**TECHNICAL BULLETINS**  
**JANUARY 1989 - DECEMBER 1989**

**SERVICE INFORMATION**  
PORSCHE CARS NORTH AMERICA, INC.

Subject: Coolant Loss/Coolant in Oil

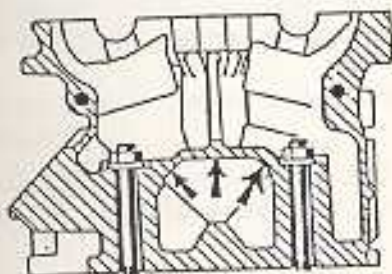
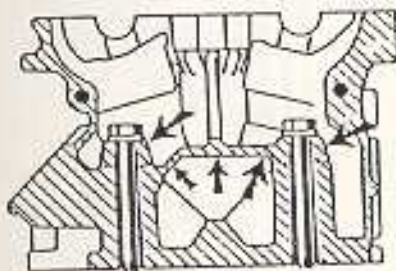
Loss of coolant or coolant in the engine oil may, among other reasons, be caused by cracks in the cylinder head cooling jacket. These cracks may begin in the area of the exhaust valve and extend toward the cylinder head mounting bolt holes. The following figures show possible fracture locations.

If coolant loss with no visible external leaks is found, the cylinder head should be checked. To test an installed cylinder head, remove the cylinder head cover and apply 1 bar maximum (14.7 psi) pressure to the cooling system. Check for leakage of coolant in the areas of the arrows and/or pressure loss.

For 944S cars, an improved cylinder head is available. The part number is unchanged.

For 928 S4 cars, a new cylinder head PN 928 104 014 03 is installed from Engine No.:

The previous version cylinder head, PN 928 104 014 02 should not be used.

**Subject:** Improved Radiator Fan Switch

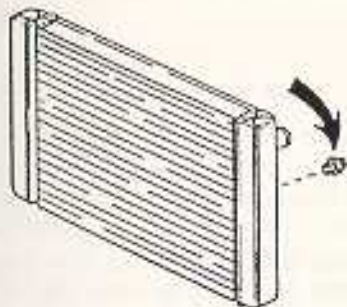
High engine temperature gauge readings (upper third of gauge) can be caused by a fan switch which switches at a higher temperature than desired. Improved switches are installed as of Model 89. They can be identified by a production date of 2/8 (Feb. 88) stamped on the switch housing.

Radiator fan switches with a production date prior to 2/8 (Feb. 1988) should not be used.

Figure 1

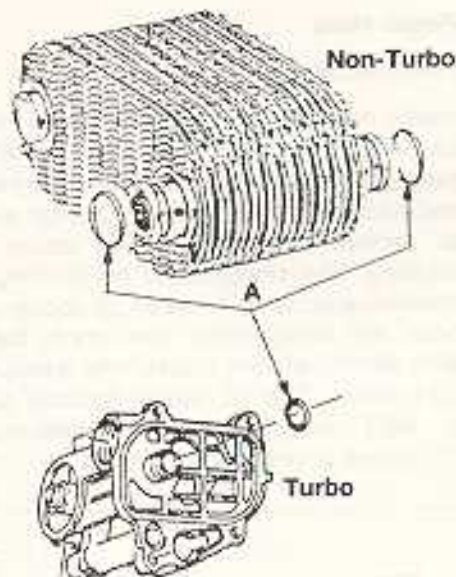
The sealing O-rings (A, figure 1) located on the oil cooler of normally aspirated cars and on the connecting pipe of the oil thermostat housing of Turbo cars, have been changed. The new version O-ring is now green in color (formerly red). When repairing, use ONLY the new version green O-rings PN 999 707 043 40.

Please note that the O-ring "A" in Fig. 1, is also installed in 944 Turbo cars. There are two O-rings on a short connecting pipe in the same place as they are found on normally aspirated cars.

Figure 1

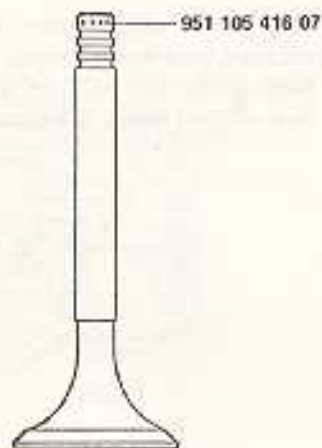
The new exhaust valve can be identified by PN 951 105 416 07 die stamped on the valve stem end. (Fig. 1)

Figure 2

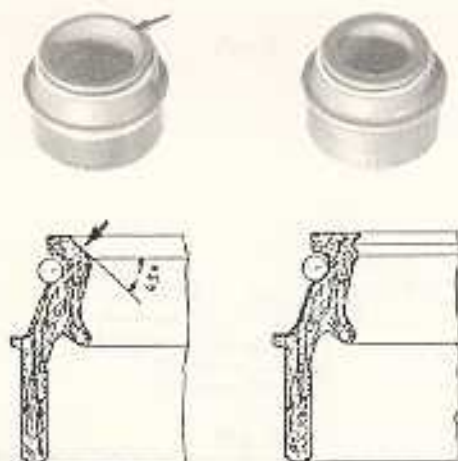
The new version valve stem seal PN 951 104 195 01 can be recognized by a 45 degree chamfer on the sealing lip. (Fig. 2)

Fig. 1

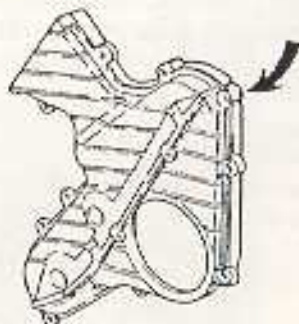
The belt Cover Opening is closed off (Fig. 1) but the hose connecting the belt cover to the air cleaner is still installed.

Fig. 4

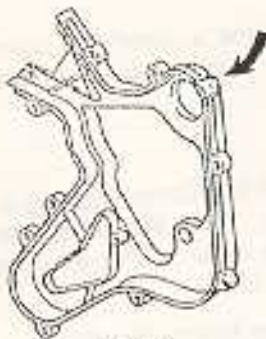
The rear part of the toothed belt cover PN 944 105 039 01, applicable to 87/88 models is superseded by belt cover PN 944 105 039 02. With this cover, the opening (Fig. 4) is closed off.

When repairing, no attempt should be made to open the closure.

Figure 1

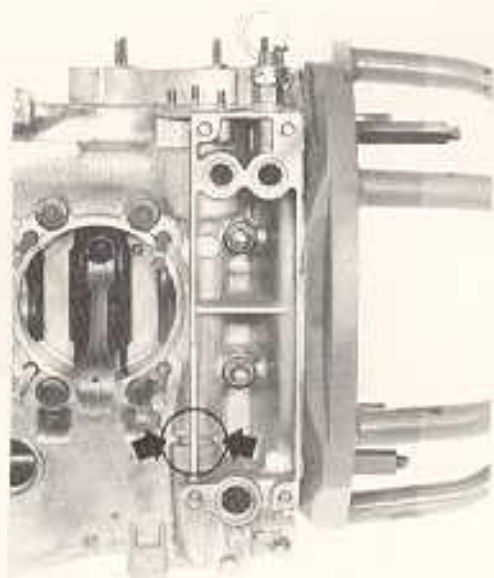
Oil leaks from the cast-in oil pipe in the right crankcase half (oil cooler area, Figure 1) can be repaired with engine removed or installed.

- Remove oil cooler
- Clean and degrease the crankcase thoroughly in the area of the pipe (circle in Figure 1) using acetone, alcohol or something similar.
- Apply a coat of Silastic 732 RTV sealing compound (Porsche PN 999 915 451 40) with light pressure uniformly until the depression (arrows in Figure 1) is filled. Smooth over the protruding sealing compound with a water coated putty knife or similar tool. Smoothing the compound is possible for a maximum of 5 minutes after application. Complete hardening time is 24 hours. Test running the engine will not disturb the hardening process.

Figure 1

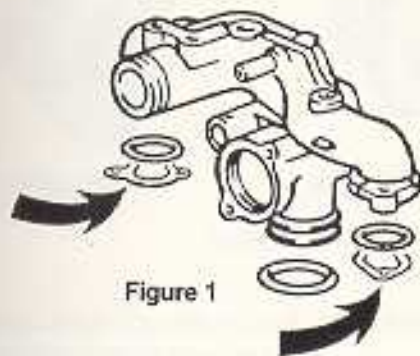
Manufacturing tolerances required installation of additional gaskets between the thermostat housing and cylinder heads (arrows in Fig. 1) on approximately 1500 engines.

The additional gaskets **must** be reinstalled during repairs.

Figure 1

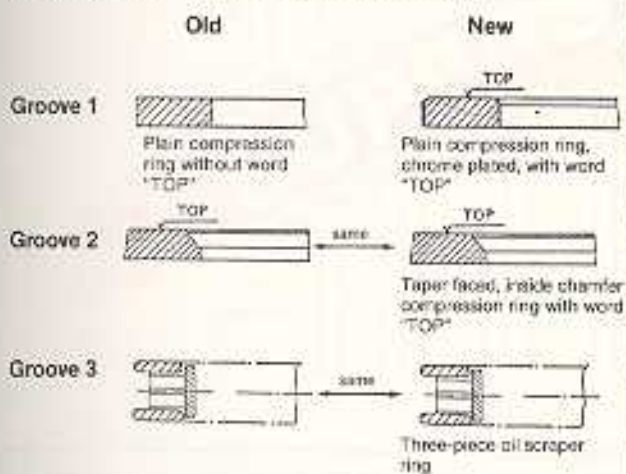
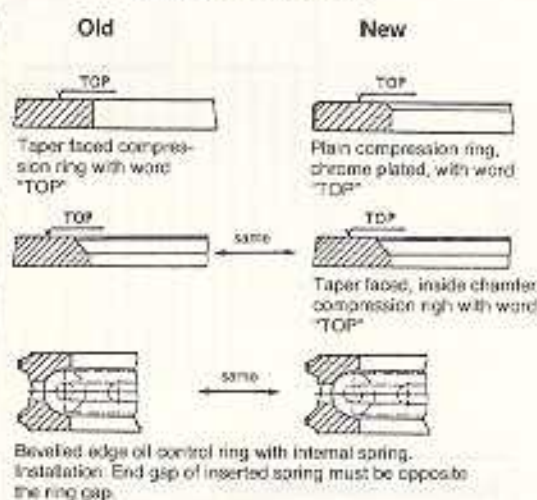
In production a three piece oil scraper ring is installed. Repair sets contain a bevelled edge ring with internal spring (Figure 1 and 2).

### 4 cyl. cars wiring diagram Sheet 6, Coordinates O,P 26

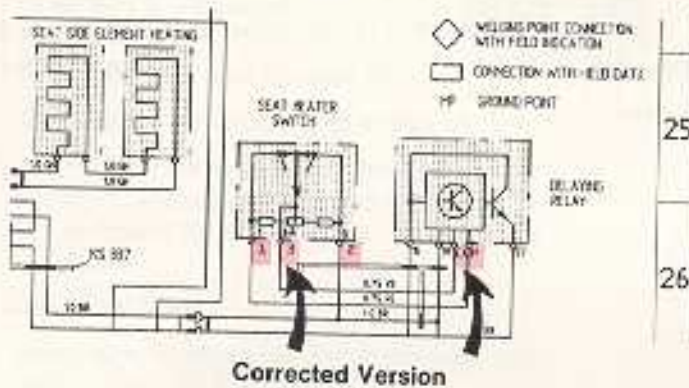
Delaying Relay Terminal E change to P  
 P change to EA  
 Seat Heater Switch Terminal E change to 1  
 P change to 3  
 A change to 2

### 6 cyl. cars wiring diagram Sheet 3, Coordinates M24

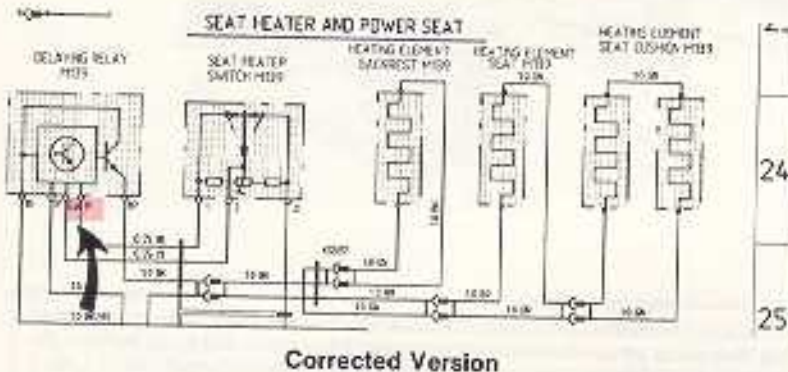
Delaying Relay Terminal E change to P  
 P change to EA

8 cyl. cars wiring diagram Sheet 6, Coordinates M,N 42

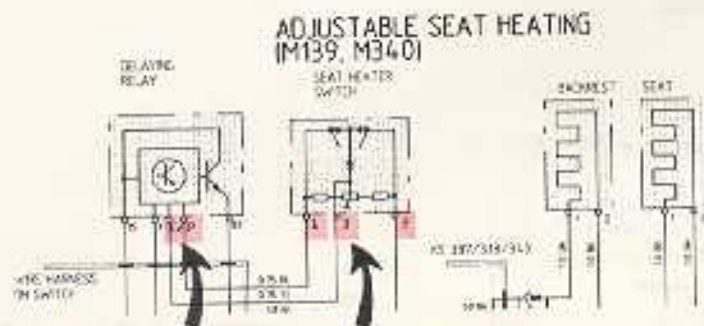
- Delaying Relay  
Terminal E change to P  
P change to EA
- Seat Heater Switch  
Terminal E change to 1  
P change to 3  
A change to 2

Figure 1

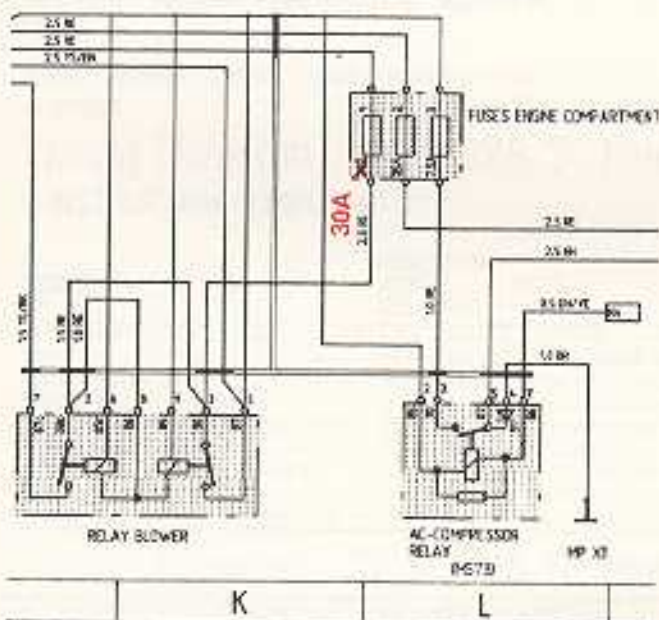
Please correct your 911 Carrera 4, Model Year 1989 Wiring Diagrams Sheet 3, Field Coordinate L28 (Figure 1).
